# STAFF REPORT

FROM: Planner II FILE NO: 3220-North Rd-672

**SUBJECT:** Development Variance Permit and Development Permit for a mixed-use

building with 42-residential rental units at 672 North Road

Figure 3: Cross Section of the building.

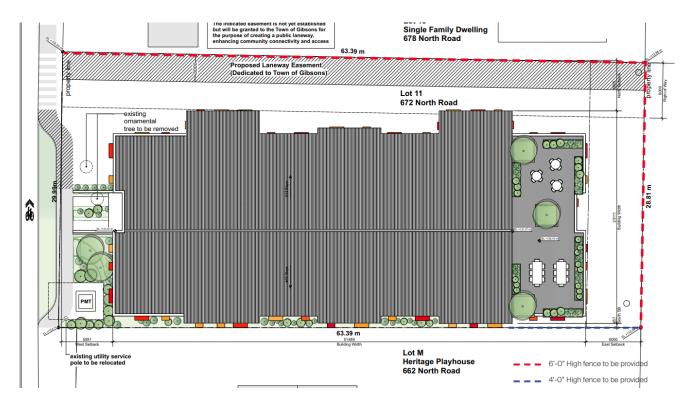
An amenity space for the apartment residents is proposed on the upper storey of the building, with a 38 m<sup>2</sup> indoor space and a larger 188 m<sup>2</sup> outdoor rooftop patio, some of which is covered,

providing residents with views towards Keats Island. This is shown in yellow in Figure 3 on the top storey.

Figure 9: Pedestrian Environment

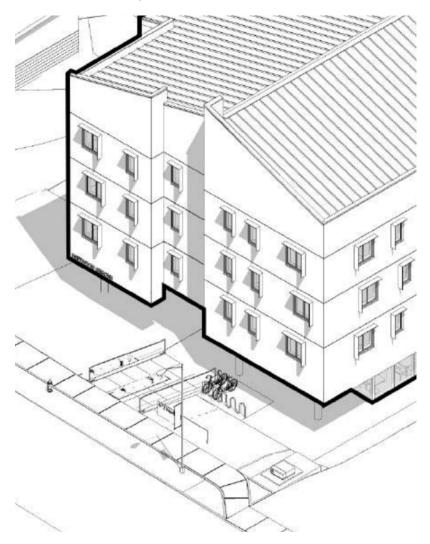
Figure 6 shows an activated street edge with prominent glazing. The building is set back 5-metres from the highway as per the Ministry of Transportation and Transit (MoTT) requirements, helping to create a public realm away from the highway. The sidewalk is to be offset from the edge of the highway as per the Town's Subdivision and Development Bylaw Number1175. The sidewalk will not be covered, however, as shown in Figure 9, there will be a covered entryway to the residential lobby and commercial unit.

Figure 12: Excerpt of the Active Transportation Network Plan's Proposed Pedestrian Network map

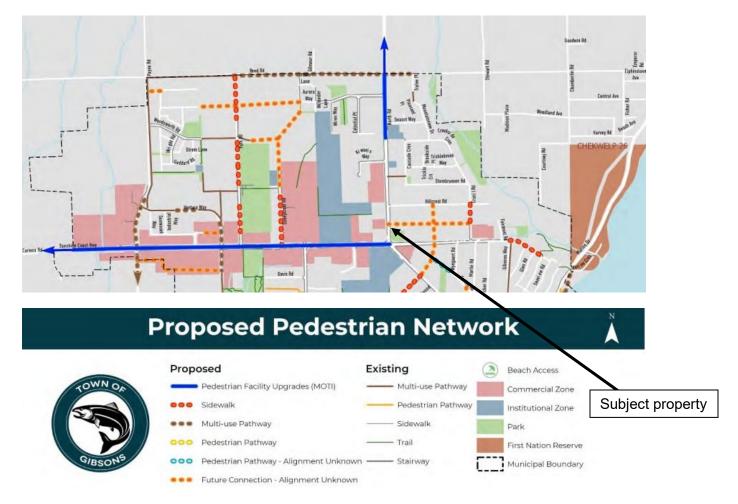
The ATNP identifies the area between Gibsons Way and Hillcrest as a proposed pedestrian and cycling connection, with the alignment currently unknown. Figure 12 provides the Proposed Pedestrian Network map from the ATNP.
